To: After Sales Official Network
Subject: Panoramic roof gasket
Date: 10/10/2025
Pages: 5

L636-A.19.25

Panoramic roof gasket

Urus SE

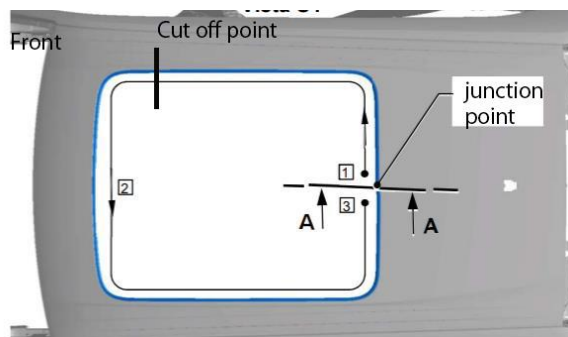
If the issue shown in the following image is identified, proceed with Operation B. Otherwise, the check concludes with Operation A

1. Check the perimeter of the sunroof, especially the corners.

2. Ensure that there is no detachment from the sheet metal and verify the seal even with the roof open.

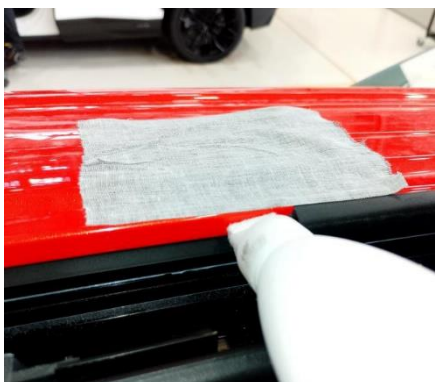
3. After protecting the paint and the lower gasket, proceed with a clean cut at the end of the indicated flange.

4. Remove the old gasket and the related glue.

5. Clean the flange with ISPI510 (dry in 2 min) and treat the surface with SIKA activator (minimum drying time: 3 min).

6. Use the original gasket reference as a starting point for mounting the new seal 4MN877459A.
Position the new gasket 0.5 mm (0.02 In.) lower than the roof.
Proceed with laying it along the entire perimeter, avoiding overstressing it and gradually pulling the red liner.
At the end, leave a margin as indicated and highlight the cut point.

7. Make a clean cut of the gasket on the indicated signal.

8. Leave the red liner in the last part of the seal and apply it starting from the end, close to the original one, to reach it slightly compressed and reduce the gap. At this point, it is possible to remove the last part of the liner.

9. Roll along the perimeter with a pressure of 55 N (40,57 lbf ft) using a tool (V03 839 306 CN) or similar.
